TECHNIC	AL N	/ELOCITY			
Client	Angmerii	ng Parish Council	Page No.	1 of 17	
Project	Land We	st of Bewley Road, Angmering, West	Project No.	24-243	
Subject	Transpor	t & Highways Technical Note	Document No	TN01	
Prepared By	TW	Checked and Authorised By	TW	Date	OCTOBER 2024

- 1.1.1 This Technical Note (TN) has been prepared by Velocity Transport Planning (VTP) on behalf of Angmering Parish Council (APC) for the purposes of evaluating a Transport Assessment (TA), submitted in support of an outline planning application (Reference: A/154/24/OUT) for a development proposal comprising of 190 residential units (Use Class C3) and a 600 sq.m community building (Use Class E(d, e) or F2(b)), together with the provision of open space, landscaping and associated infrastructure on land west of Bewley Road in Angmering, West Sussex.

Figure 2-2: Local Junctions

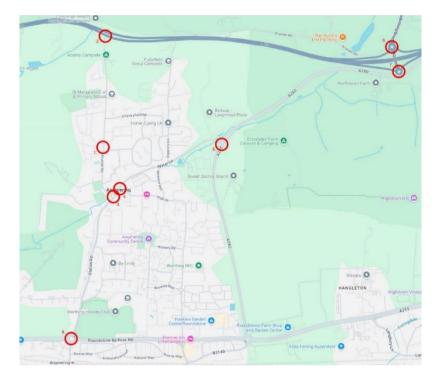
- 2.6.1 This section of the note reviews/provides comment on the junction capacity modelling exercise undertaken by i-Transport as part of the submitted TA.
- 2.6.2 The 8 junctions that were assessed are listed below and shown in **Figure 2-2**.
  - Bewley Road/Arundel Road Priority Junction
  - A27/Arundel Road Priority Junction
  - Arundel Road/Water Lane Priority Junction
  - High Street/Water Lane Priority Junction
  - Water Lane/A280 Priority Junction

- A280/A27/Arundel Road Roundabout (North)
- A280/A27/Titnore Lane Roundabout (South)
- Blue Star Roundabout
